## **NextEra Energy Appeal of PRR 830 Regarding Reactive Power**

NextEra Energy Resources (NextEra) respectfully requests the ERCOT Board of Directors remand PRR 830 to TAC with instructions to address material defects in the PRR as discussed below or, in the alternative, approve the PRR as set forth in Attachment A.

### **November 3, 2009 Comments of NextEra Energy Resources Regarding PRR 830**

**PRR 835**

**Figure 1. +/- .95 Power Factor Criteria**

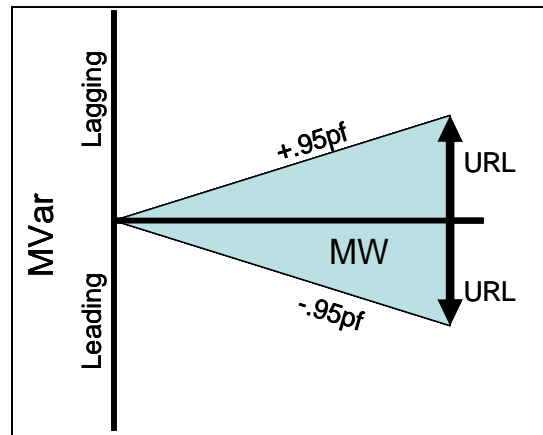
- (1) WGRs are required to provide VSS and must be capable of operating at a power factor of +/- .95 or less over the full (MW) net power output range of the Resource, supplied to the ERCOT Transmission Grid, and measured at the POI to the TDSP in order to maintain a Voltage Profile established by ERCOT. This requirement is graphically depicted in Figure 1. The quantity of Reactive Power measured at the full rated capability of the Resource is the URL.

**Figure 2. Fixed URL Criteria (based on +/- .95 Power Factor)**

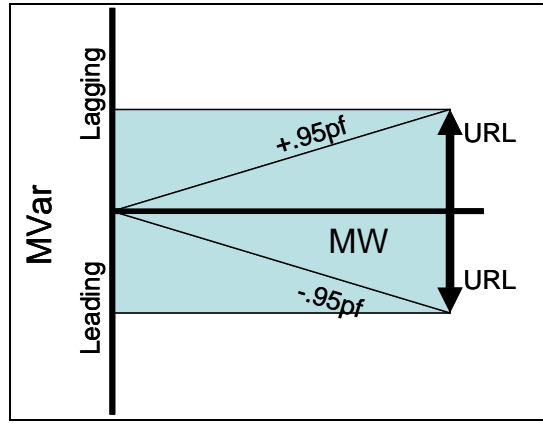
- (2) WGRs may be required to provide VSS beyond what is required in paragraph (1) above only if the TSP or ERCOT shows, through a System Impact Study, that such capability is required to ensure grid safety or reliability. The amount of additional reactive capability required to be provided by the Resource shall not exceed the URL specified in paragraph (1) above and be available at all MW output levels over the full output range of the Resource. This requirement is graphically depicted in Figure 2. This additional reactive capability may be provided through any combination of automatically switchable static reactive devices (i.e. switched shunts) and/or dynamic reactive devices (i.e. SVC, Statcom, etc.) so long as the requirement to ensure safety and reliability is met.

# Comparison of PRR835 to PRR830 and FERC Order 661-A

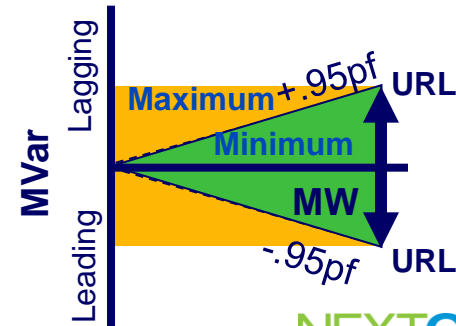
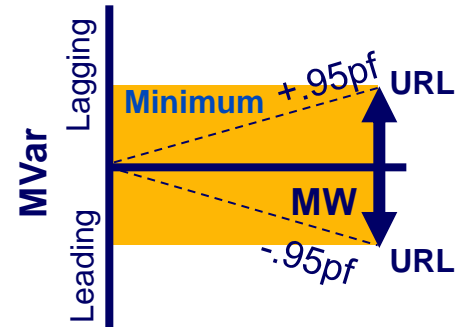
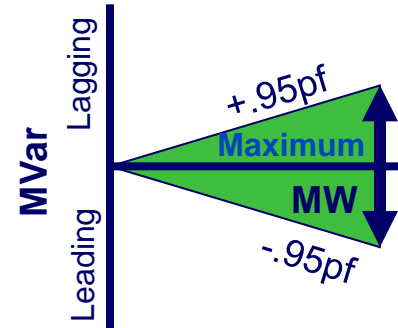
- FERC Order 661-A
  - Adopts +/- 0.95PF range as the maximum requirement
  - Requires wind plants to maintain the required power factor range only if the Transmission Provider shows, through the System Impact Study, that such capability is required of the plant to ensure safety and reliability
- PRR830
  - Adopts the URL measured at +/-0.95 PF and maximum net MW output
  - Requires URL over the full operating range of the plant
- PRR835
  - Adopts +/-0.95PF as the minimum reactive capability
  - May require URL over the full operating range of the plant only if the Transmission Provider demonstrates it is needed to ensure safety and reliability through a System Impact Study

# PRR830 will result in redundant and excessive reactive capability where it is not needed

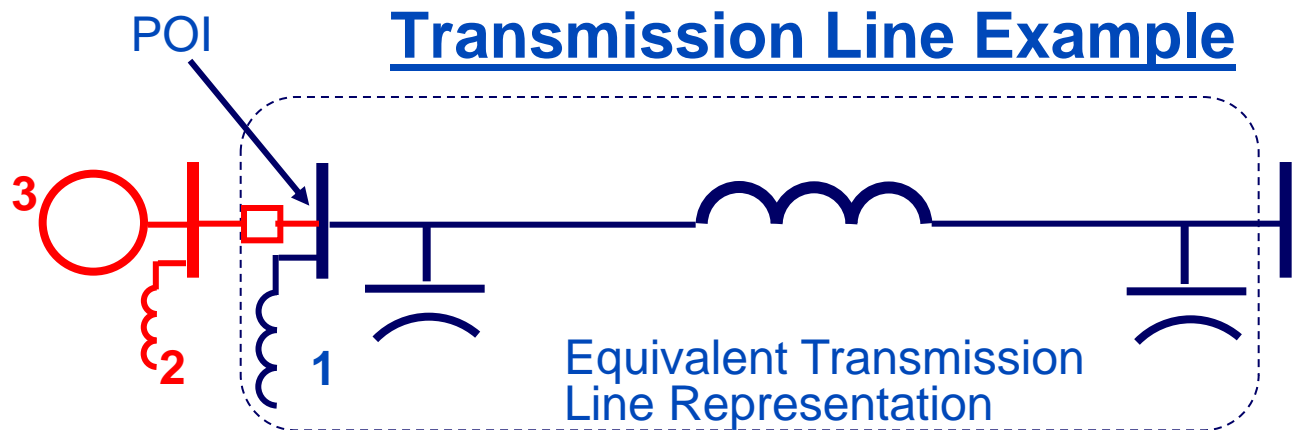
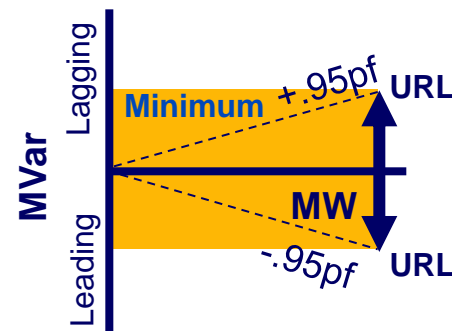
1. Transmission Owner must provide shunt reactors to offset line charging when wind is calm and generator is not generating
2. PRR830 would have the Generator install an additional shunt reactor to meet its URL requirement for leading reactive capability over its range of output
3. Inherent Generator reactive capability

**PRR830 will result in the wasteful installation of redundant reactive resources.**

**PRR835 ensures system safety and reliability without mandating investment in reactive capability for providing VSS where it is not needed**
